**NOTICE OF FINAL FINDINGS, CONCLUSIONS, AND DECISION
OF THE CITY OF PORTLAND DESIGN COMMISSION
ON AN APPEALED ADMINISTRATIVE DECISION
(Type II Process)**

CASE FILE: LU 13-131079 DZM – 115 N Cook

The applicant proposes construction of a 6-story mixed-use building in the Albina Community Plan District consisting of:

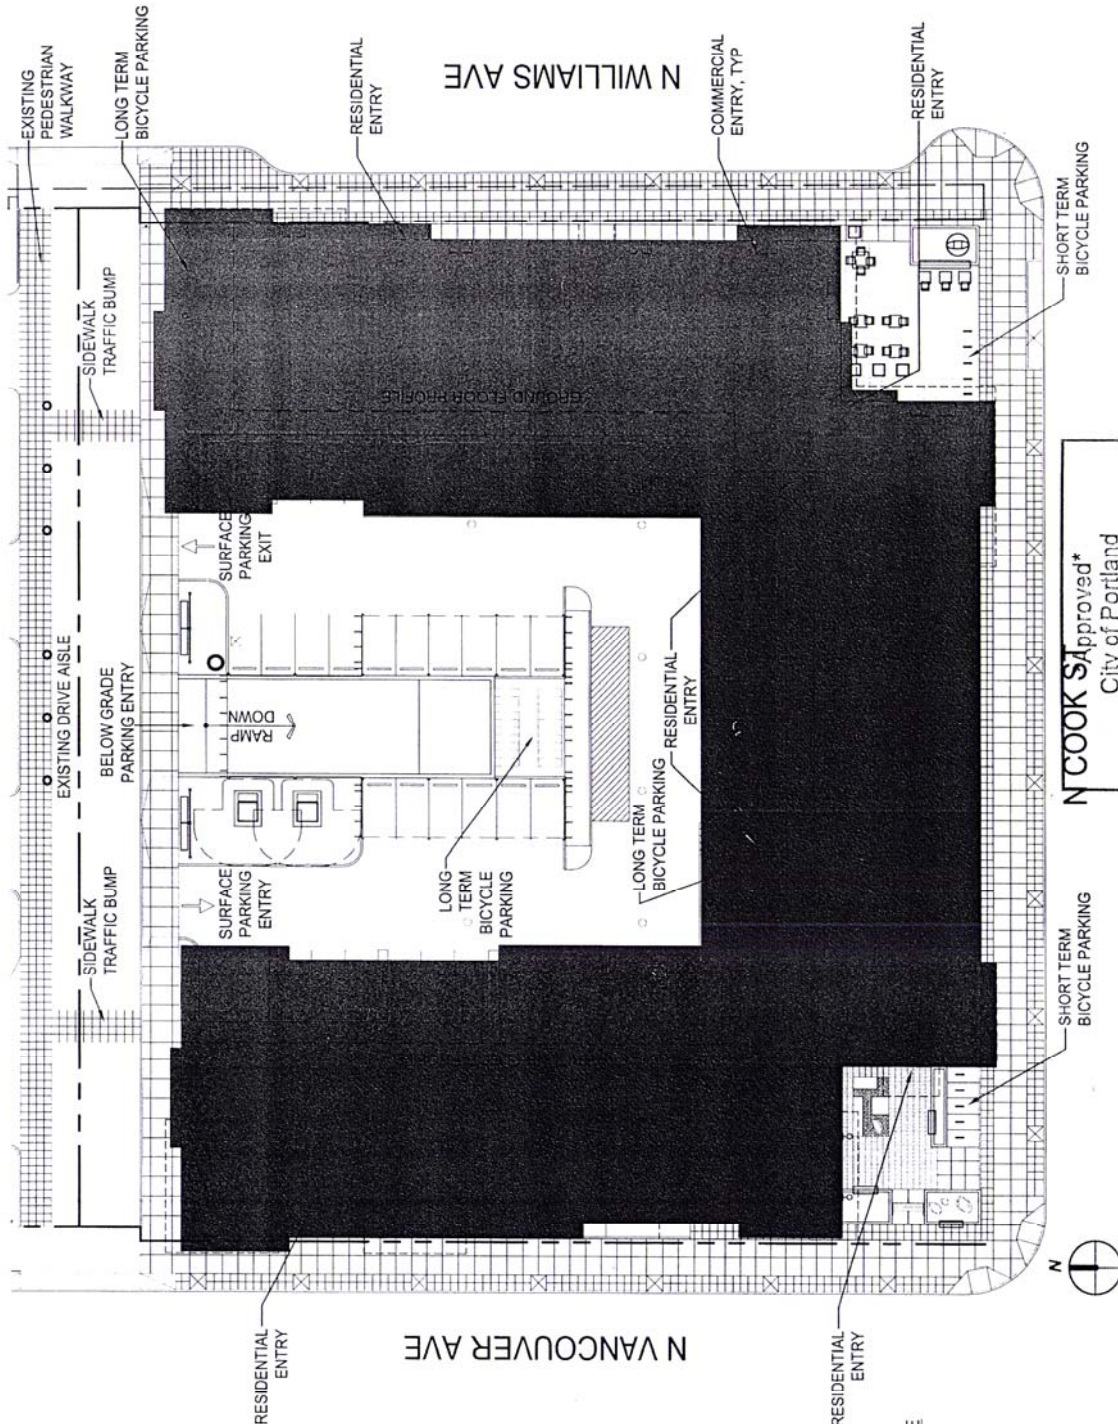
Findings: Staff initially had concerns about potential conflicts along the N Ivy frontage as this private driveway essentially acts as a driveway for the New Seasons property to the north, as well as vehicular access for this property. At the behest of the Bureau of Transportation, the applicant changed the initial proposal of three in-out driveways to one in-out driveway for the underground garage with the at-grade parking area served by a one-way aisle. As N Williams and N Vancouver are both highly traveled routes for pedestrians, bicycles, private vehicles, and transit, neither of these streets are appropriate for garage access. Similarly, this particular stretch of N Cook receives vehicular traffic to and from the I-5 ramp, the intensity of which varies depending on the time of day. Therefore, staff concedes that the private access along N Ivy is the preferred location for vehicular access to this property. Along this edge, a continuous paved pedestrian sidewalk will highlight the potential presence of pedestrians and the reduced and offset curbcuts is intended to encourage more cautious driving behavior. The proposal also includes improvements to the sidewalks on the other three frontages, including planting of street trees. In addition, the applicant proposes two courtyards at the southwest and southeast corners, which feature constructed landscape elements to further buffer pedestrians from the areas of highest potential conflict.

Since the initial decision was issued, the applicant has made changes to the proposal, based on direction provided by the Design Commission. One of these changes is related to the 6'-0" walkways along the interior parking court, which the Commission directed the applicant to make more inviting and friendly as many of the users of the building would utilize these walkways. In the October 24th revision, the applicant introduced benches and planters into the required 6'-0" walkways, thereby making them friendlier, but also reducing their required width. Staff suggested narrower parking stalls and aisles in order to provide for generous sidewalks. Staff noted that if a 6'-0" wide clear pedestrian pathway is not provided, then a modification to the reduced width would be required.

In addition, since the initial Decision of Denial, the applicant now proposes to locate two transformers at the north end of the interior parking court along N Ivy. The Design Commission previously directed the applicant to relocate these transformers below grade and in the right-of-way in order to maintain a pedestrian network that is as pleasant as possible. However, since the September 19th hearing, staff has been educated, by the utility company, on the challenges of such a solution. Staff anticipated that this issue would be further illuminated at the October 24th hearing through testimony by the utility company. The applicant indicated they would accept a condition of approval related to this issue, as well as the approved solution's impact of the proposed trellis which is intended to obscure the parking spaces below.

In addition, at the October 24th hearing, the Commission was not satisfied with the treatment afforded to the interior walkways, noting that they required additional width and additional consideration, but desired to move the project forward.

Therefore, with the conditions of approval that the width of the interior sidewalks be increased to 8'-0" with a minimum of 6'- clear path and that the applicant provide enhanced details of the walkways, walls, and ceilings of the interior walkways to be submitted and approved through a Type II Land Use Review, with the work completed prior to obtaining a Certificate of Occupancy, and that a planted green screen and gate be installed around the transformers and above all the parking at the center, this guideline is met.

- B. There shall be a planted green screen fence and gate installed around the transformers and above all the parking at the center;
- C. A single type of horizontal bike rack, illustrated on sheet 7.4, shall be used;
